Access Compliance Report

Public Rights-of-Way

(Curb Ramps)

Intersection ID: 10019902	Main Street: ARCO_CORPORATE_DR	Cross Street: N/A	Location: NW
ADA ID: 7BDDD2F3A7F9	Ramp Type: PerpDiag	Initial Pass/Fail: Fail	Overall Compliance: No
Severity Score: 22.5			
Codes/Mitigation Info/Possible Solution		Field Measurements/Component Compliance

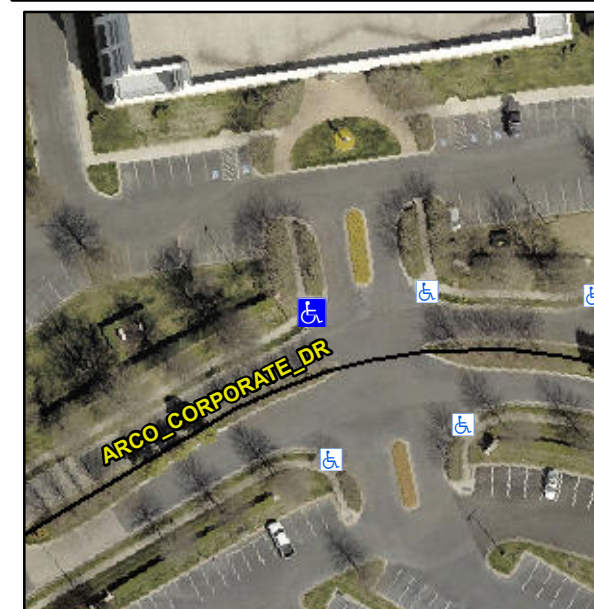
R304.5.1, R304.2.2, R304.5.3

Compliance	Description	Data	Compliance	Description	Data
N/A	Ramp Length (in)	50.0	No	Ramp Slope (%)	11.6
No	Ramp Width (in)	41.0	No	Ramp XSlope (%)	3.2
N/A	Flare Type LT	N/A	N/A	Flare Type RT	N/A
N/A	Flare Slope LT (%)	N/A	N/A	Flare Slope RT (%)	N/A
N/A	Flare Traversable LT?	N/A	N/A	Flare Traversable RT?	N/A
N/A	Landing Length (in)	N/A	N/A	DWS Provided?	N/A
N/A	Landing Width (in)	N/A	N/A	DWS Contrast?	N/A
N/A	Landing Slope (%)	N/A	N/A	DWS Length (in)	N/A
N/A	Landing X Slope (%)	N/A	N/A	DWS Full Width?	N/A
N/A	Landing Curb? (Y/N)	N/A	N/A	DWS Offset (in)	N/A
N/A	Shared Landing?	N/A			
N/A	Gutter Ponding?	N/A	N/A	Gutter Slope (%)	N/A
N/A	Gutter Lip Ht (in)	N/A	N/A	Gutter X Slope (%)	N/A
N/A	Painted X Walk1?	No	N/A	Painted X Walk2?	No
	X Walk 1 Direction	To S		X Walk 2 Direction	To E
N/A	X Walk 1 Width (in)	N/A	N/A	X Walk 2 Width (in)	N/A
	X Walk 1 Slope (%)	2.4		X Walk 2 Slope (%)	3.6
	X Walk 1 X Slope (%)	2.3		X Walk 2 X Slope (%)	3.3

Remove & Replace Curb Ramp With Two New Directional Ramps or Equivalent.
